re: Grading and Site Servicing Review
Proposed Industrial Development
6160 Thunder Road, Ottawa, Ontario

date: August 12, 2024

file: PG5161-MEMO.04 Revision 1

- Figure 1 – EPS Block Installation
- LWF Requirement Markup

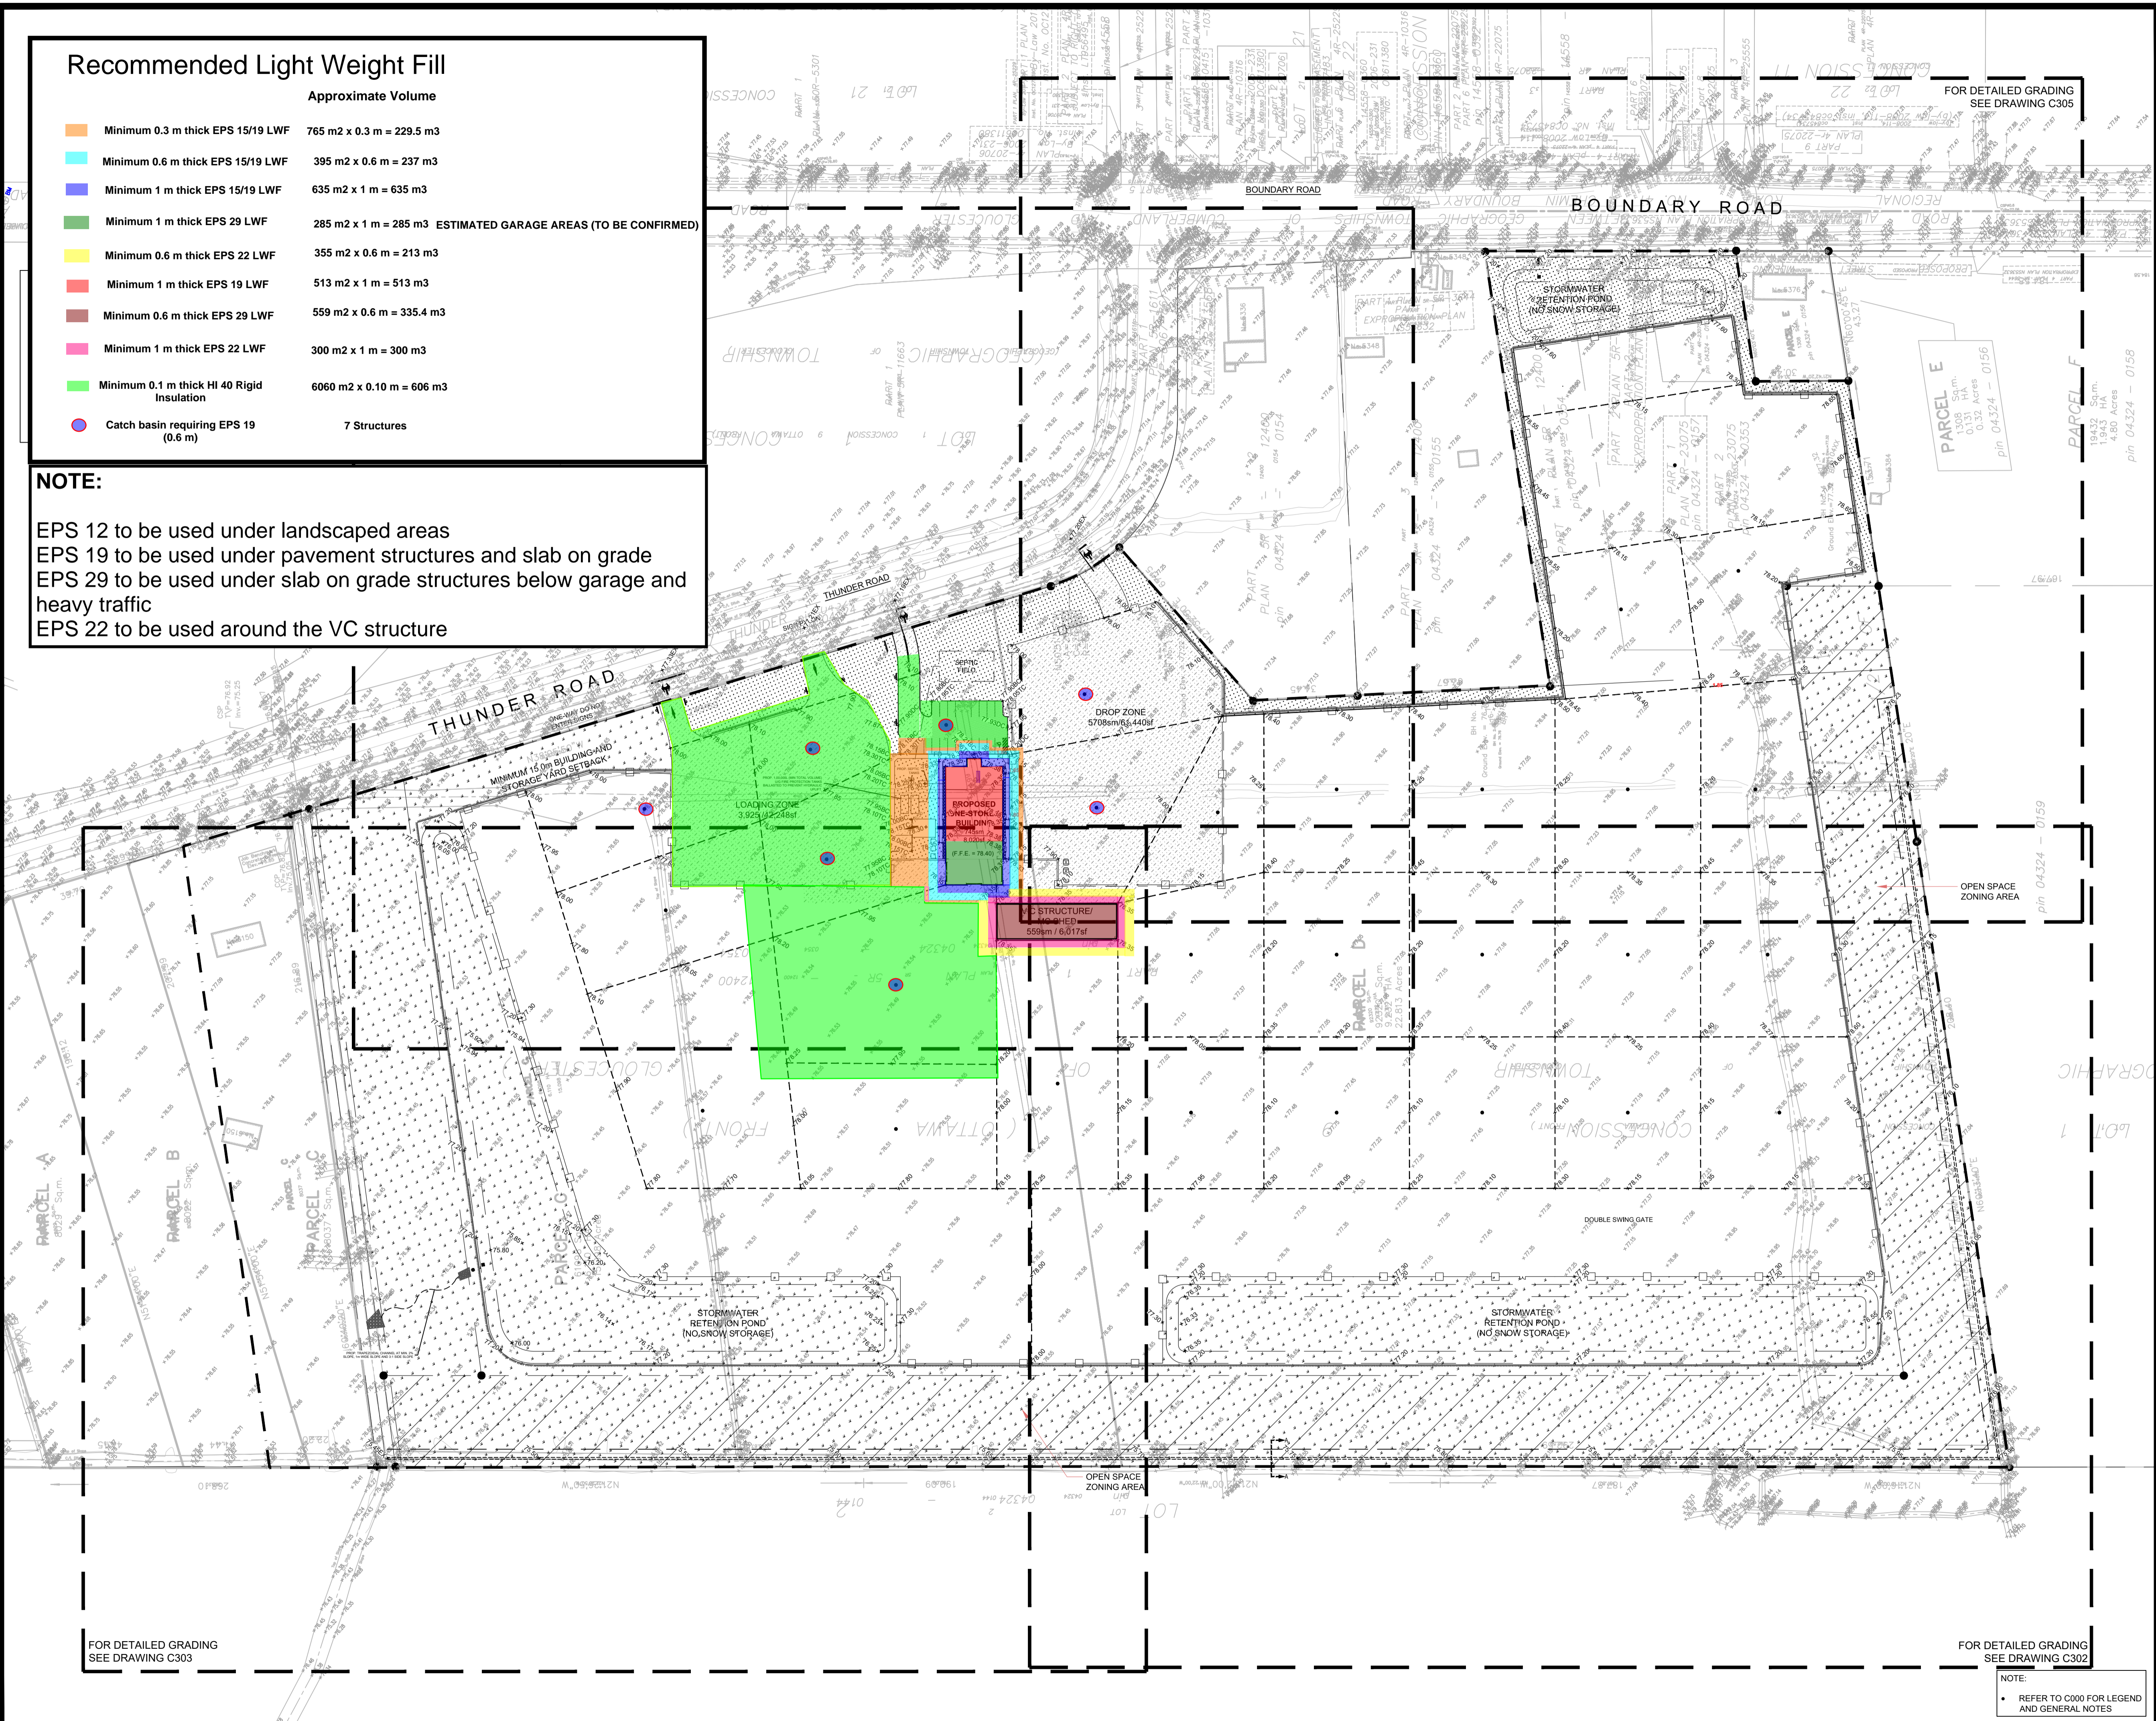
Below the pavement and landscaped areas, the LWF EPS blocks should be comprised of EPS 19 and EPS 15 blocks respectively and should be placed as per the marked-up site plan attached to the end of this memorandum.

Due to the smaller permissible grade raise exceedance in the paved an storage area, a settlement surcharge program can also be conducted within the noted areas in light green (refer to attached mark-up) on the attached site plan. It is recommended to pre-grade the proposed parking and storage areas with approved fill and surcharge the area to a minimum of 0.6 m over the proposed final grade, over an anticipated period of six (6) to eight (8) months. Paterson shall monitor the settlement of the ground to confirm settlement rates and completion of the surcharge program. The completion of a successful surcharge program would eliminate the need for LWF within these areas.

In the gravel storage area, it is expected that approximately 25 to 50 mm of settlement can be expected over time. Therefore, the to maintain minimum drainage slope along the servicing lines some catchbasins will require LWF. A minimum of 0.6 m of EPS 19 extending 1.2 m around the catchbasin should be used to protect the structures as indicated on the attached plan.

Approximate Volume
■ Minimum 0.3 m thick EPS 15/19 LWF	765 m ² x 0.3 m = 229.5 m ³
■ Minimum 0.6 m thick EPS 15/19 LWF	395 m ² x 0.6 m = 237 m ³
■ Minimum 1 m thick EPS 15/19 LWF	635 m ² x 1 m = 635 m ³
■ Minimum 1 m thick EPS 29 LWF	285 m ² x 1 m = 285 m ³ ESTIMATED GARAGE AREAS (TO BE CONFIRMED)
■ Minimum 0.6 m thick EPS 22 LWF	355 m ² x 0.6 m = 213 m ³
■ Minimum 1 m thick EPS 19 LWF	513 m ² x 1 m = 513 m ³
■ Minimum 0.6 m thick EPS 29 LWF	559 m ² x 0.6 m = 335.4 m ³
■ Minimum 1 m thick EPS 22 LWF	300 m ² x 1 m = 300 m ³
■ Minimum 0.1 m thick HI 40 Rigid Insulation	6060 m ² x 0.10 m = 606 m ³
● Catch basin requiring EPS 19 (0.6 m)	7 Structures

NOTE:
 EPS 12 to be used under landscaped areas
 EPS 19 to be used under pavement structures and slab on grade
 EPS 29 to be used under slab on grade structures below garage and heavy traffic
 EPS 22 to be used around the VC structure
